RELOCATION OF GATES 10 & 11

**PROJECT NO. 54 1019 1765
CONTRACT NO. 54-2-20-2111**

ADDENDUM NO. 1

March 27, 2020

DRAWING G017
PROJECT 54 1019 1765
SHEET 8 OF 127

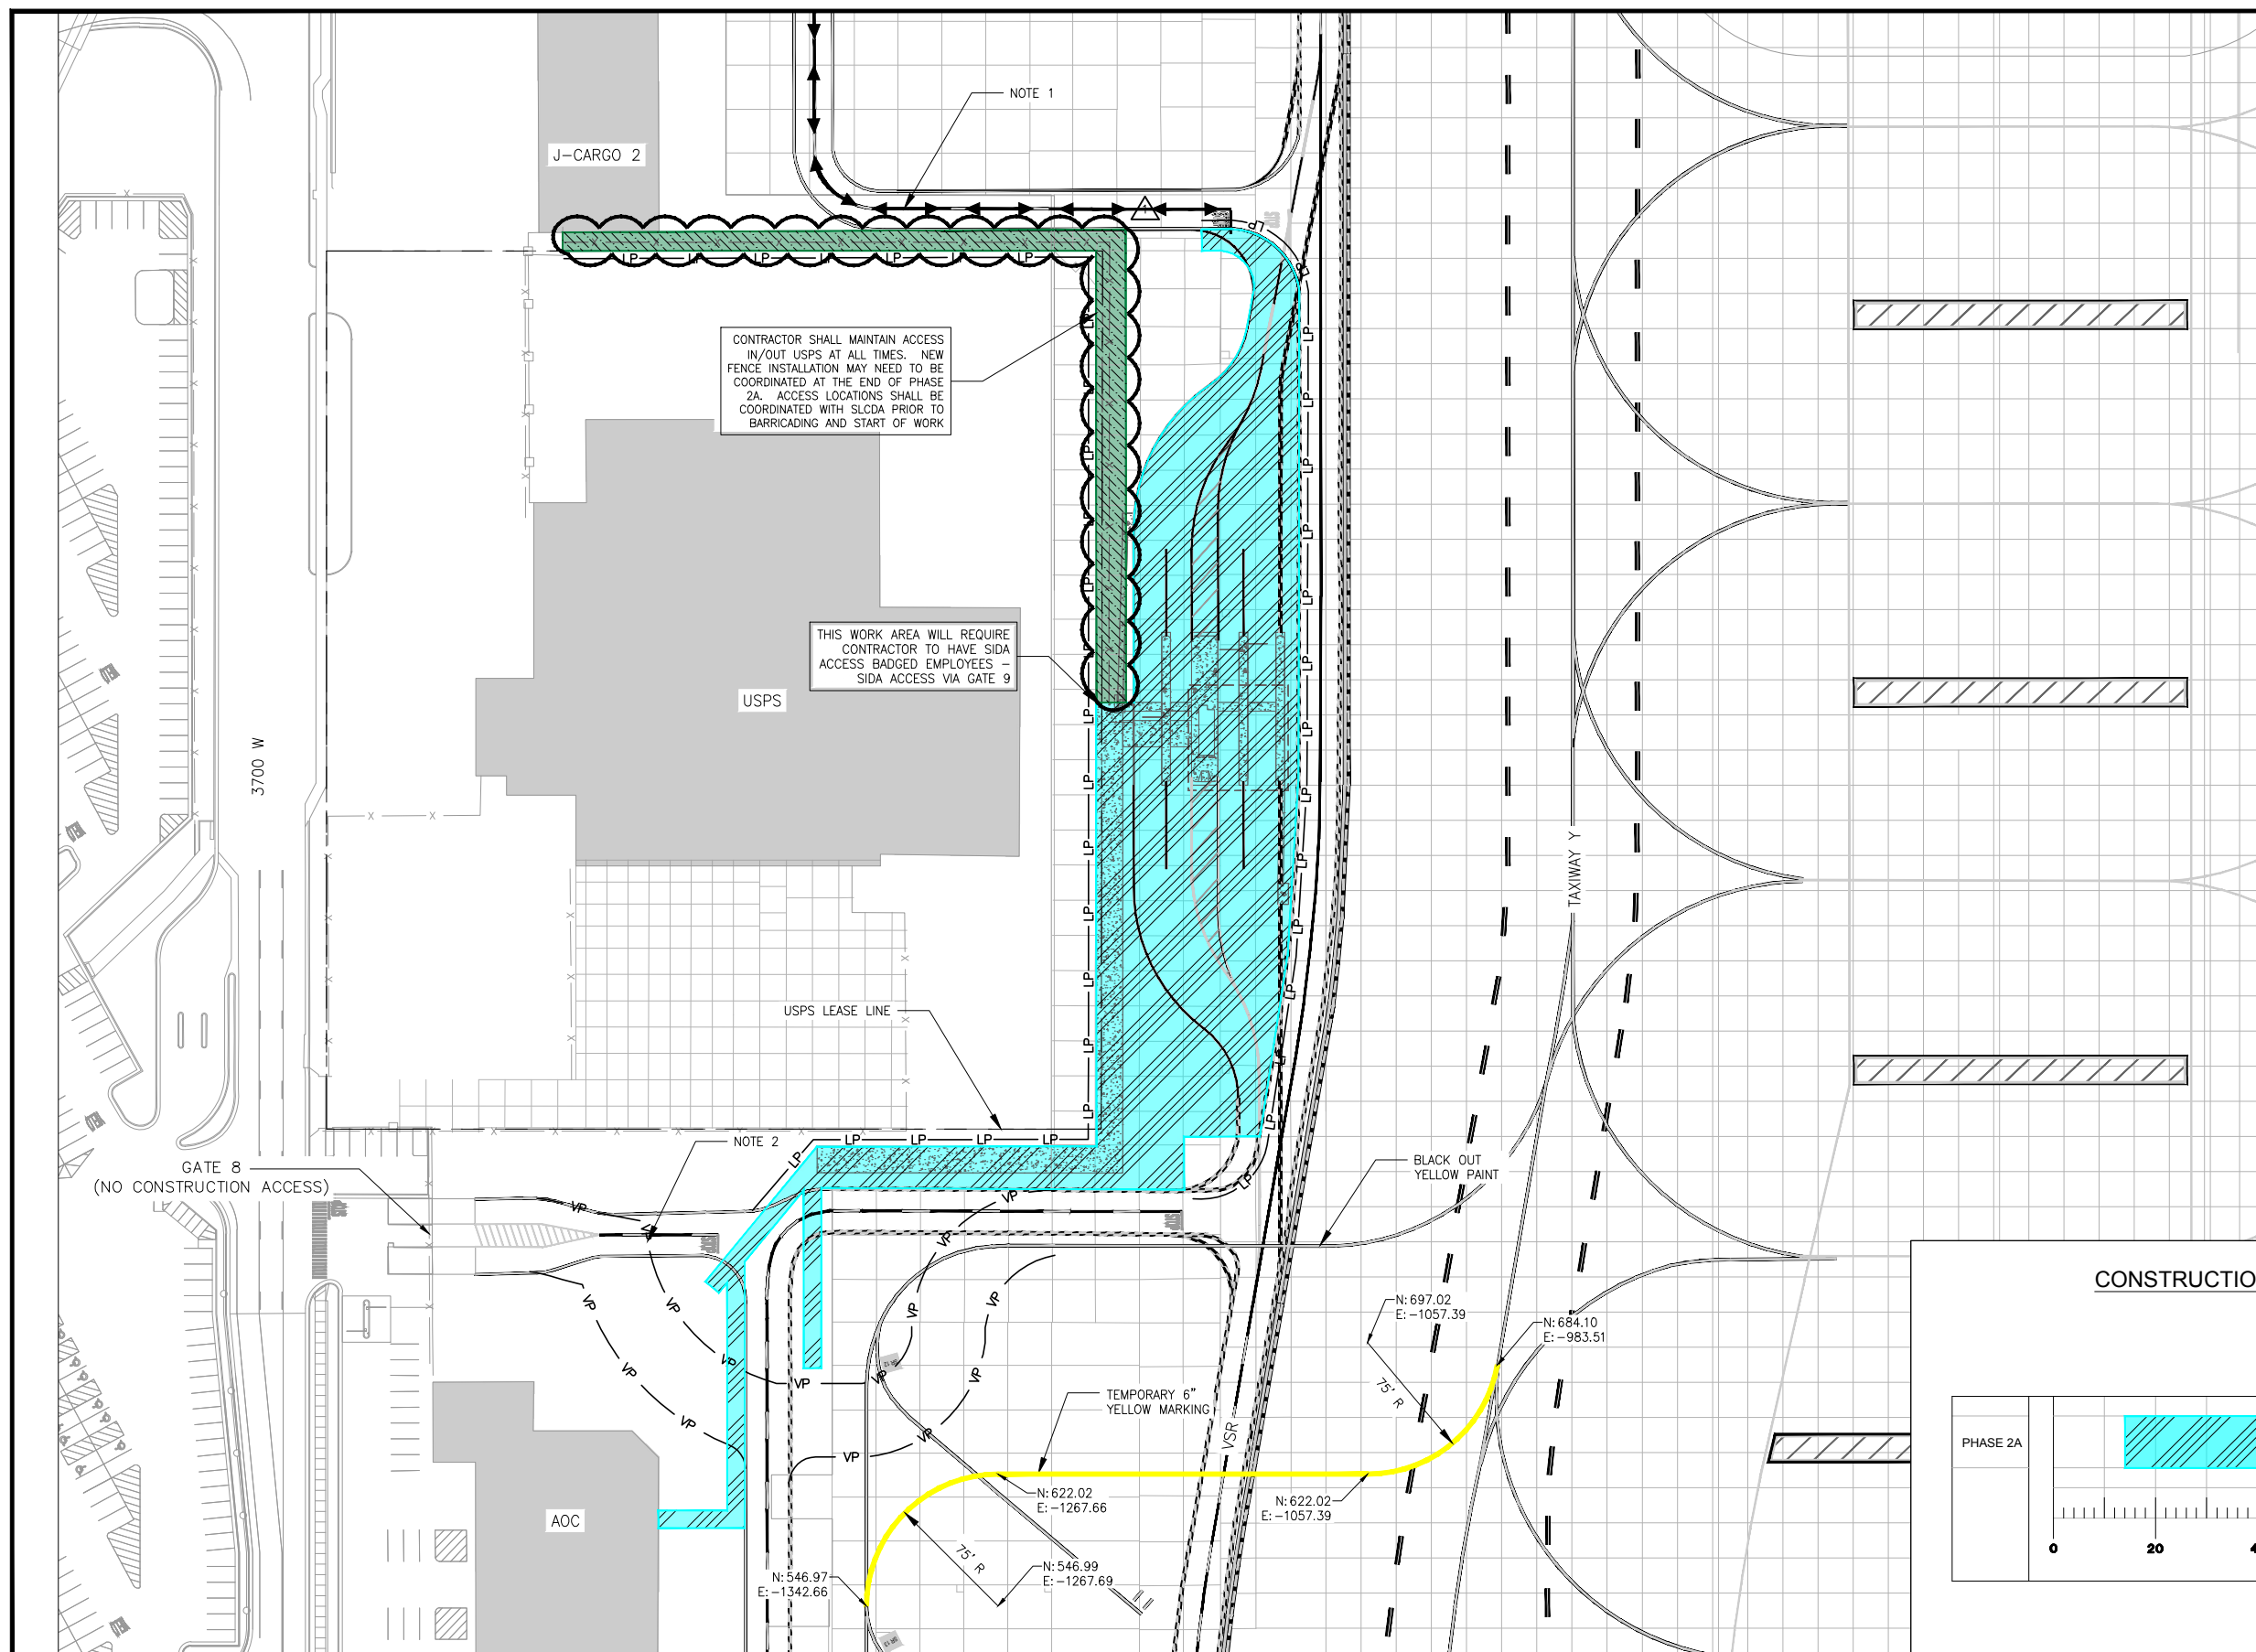
G017 Addendum No. 1 - Added call out for Temporary 24' double swing gate for Phase 1D access.

BID DOCUMENTS
DRAWING C251
PROJECT 54 1019 1765
SHEET 31 OF 127

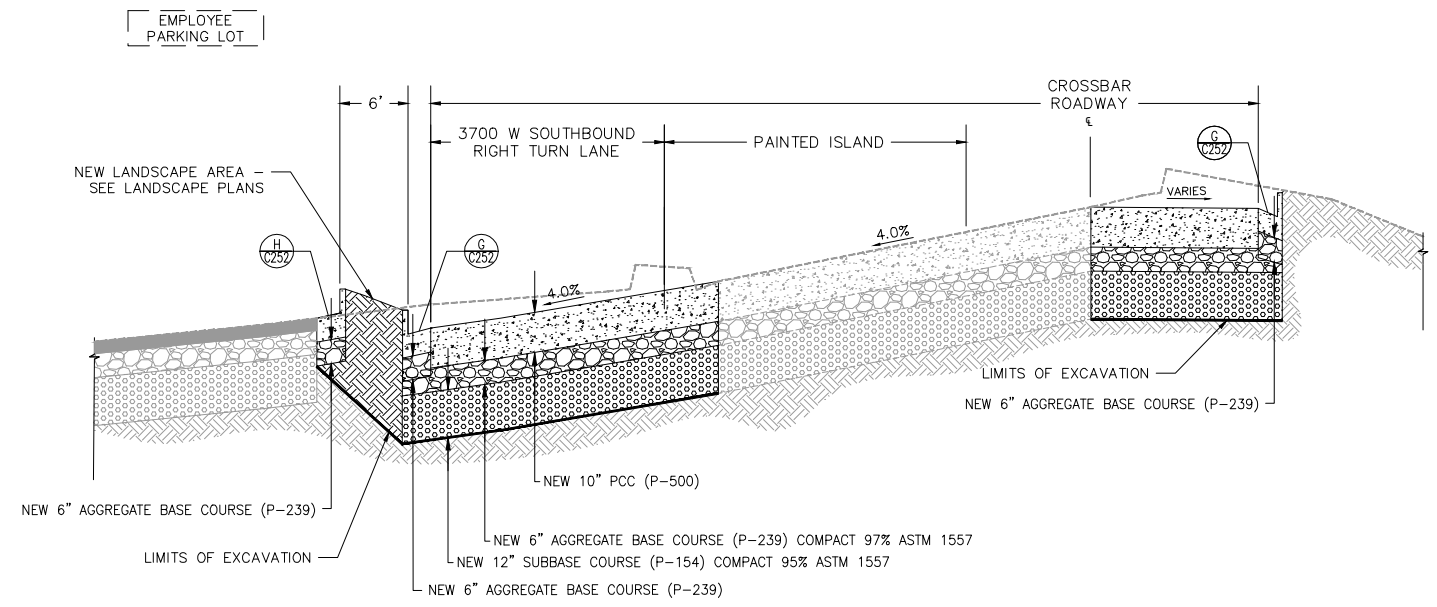
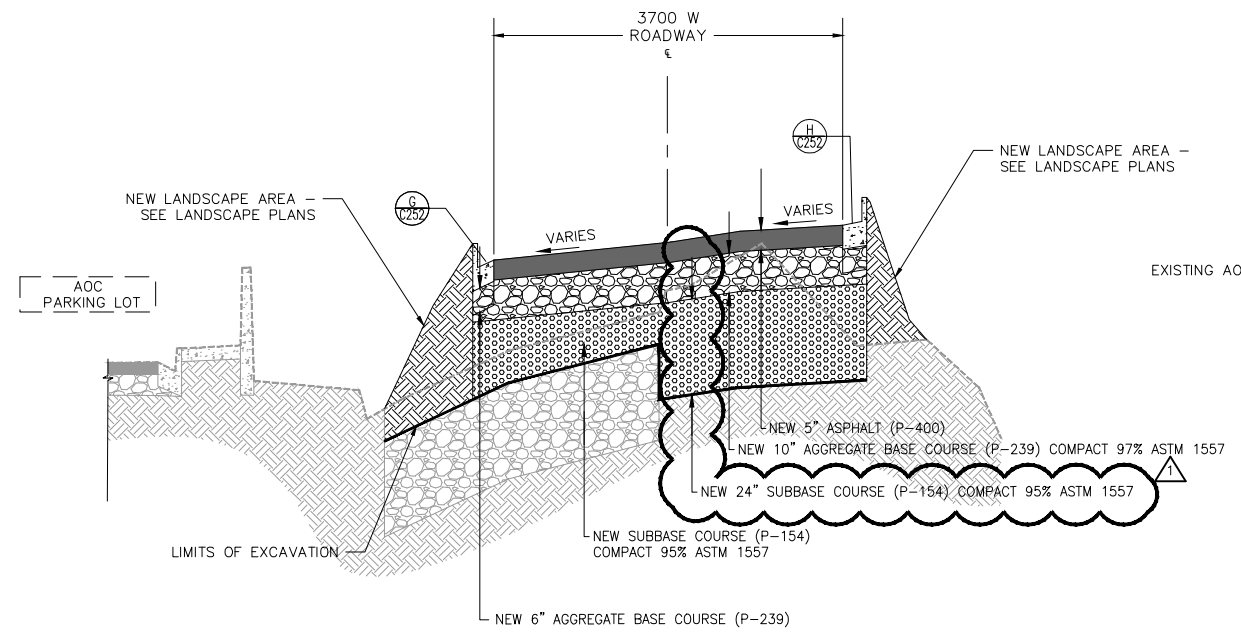
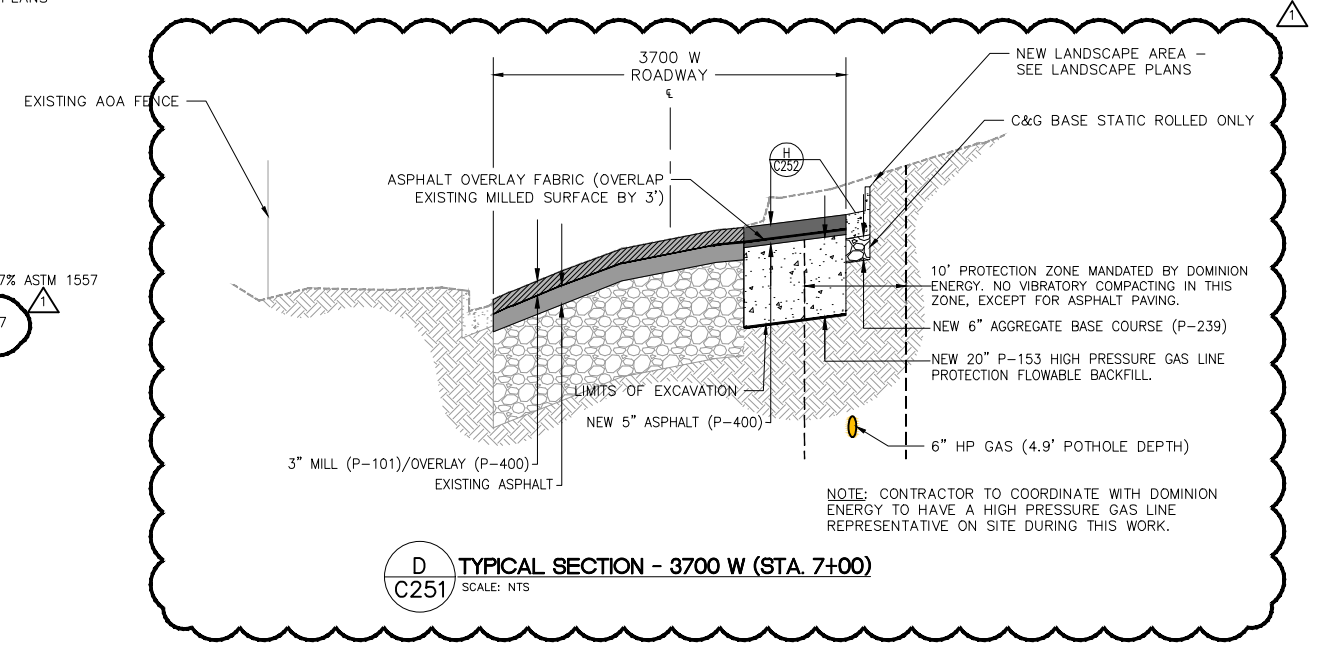
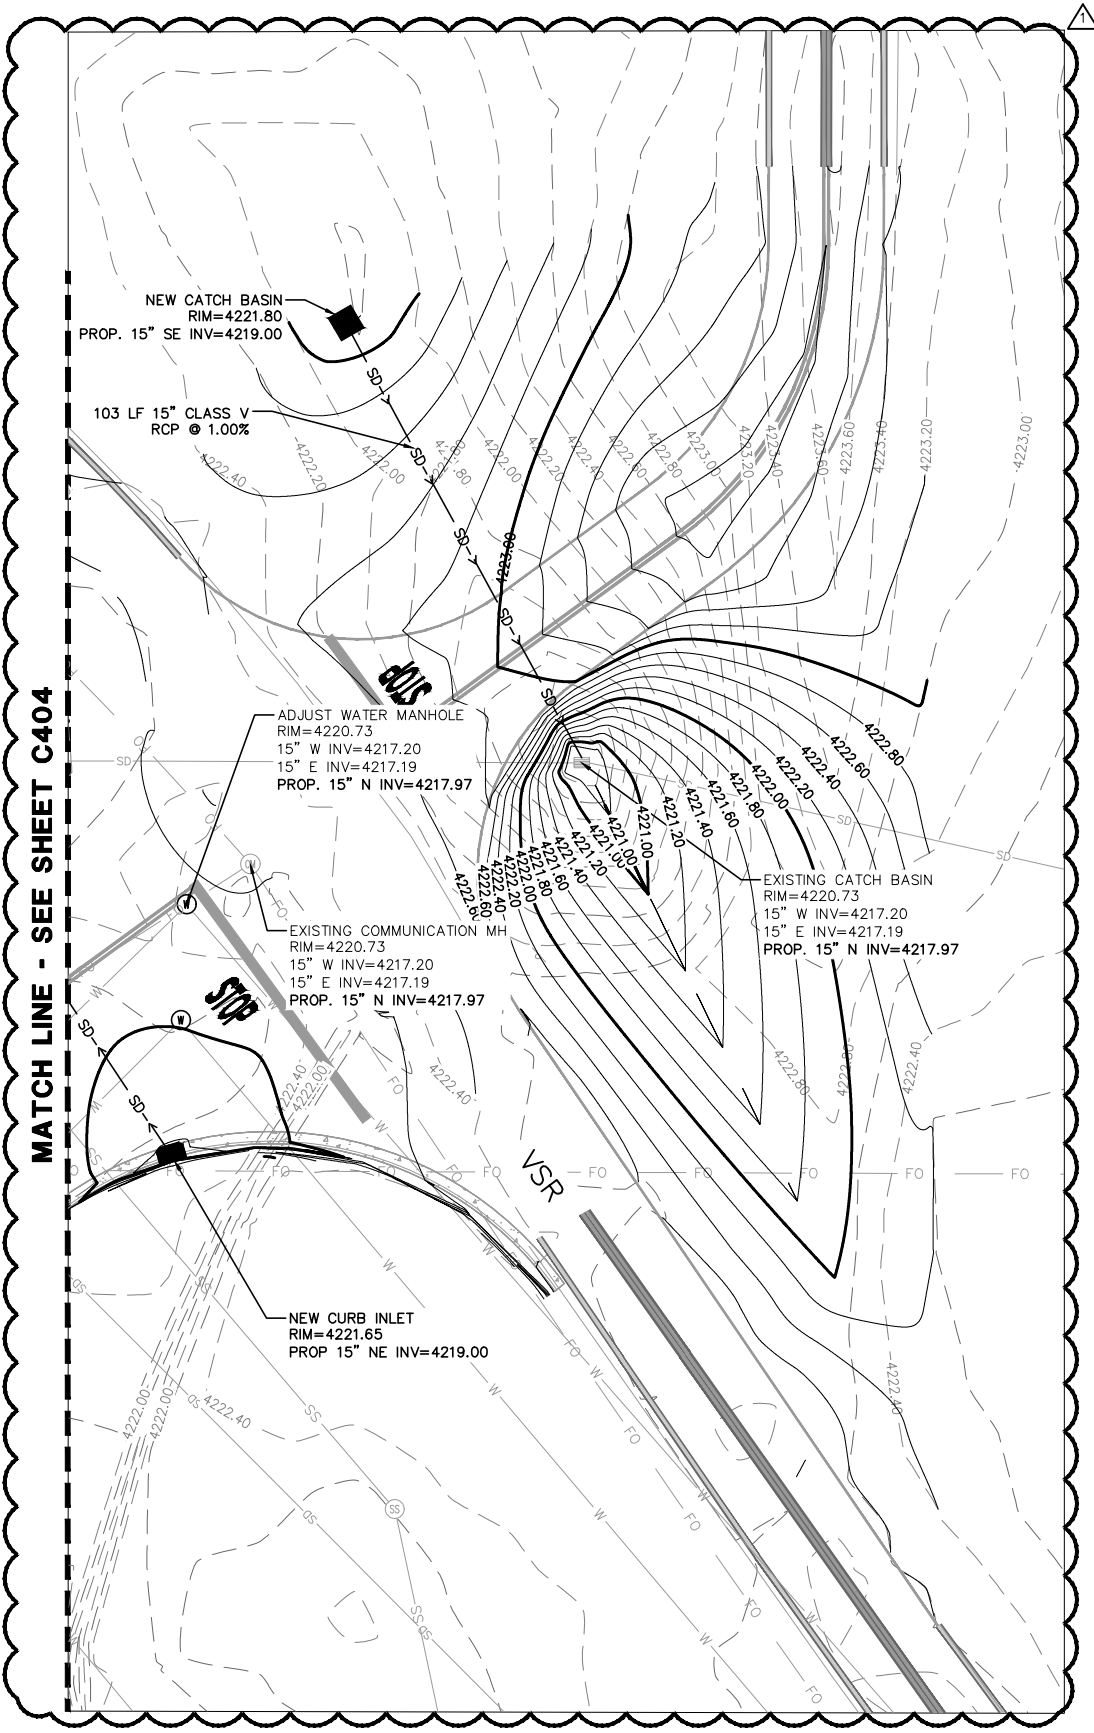
Question 3 - The Typical Section for the Vehicle Service Road refers to landscaping on both shoulders of the roadway. The landscape drawings do not show any landscaping. What type of landscaping should it receive?

Answer - There is no landscaping required along the shoulders of the Vehicle Service Road. The Typical Section for the Vehicle Services Road will be updated in Addendum No. 1 to PLACE 5-INCH DEEP MILLINGS IN DISTURBED AREAS OUTSIDE OF THE NEW PAVEMENT.
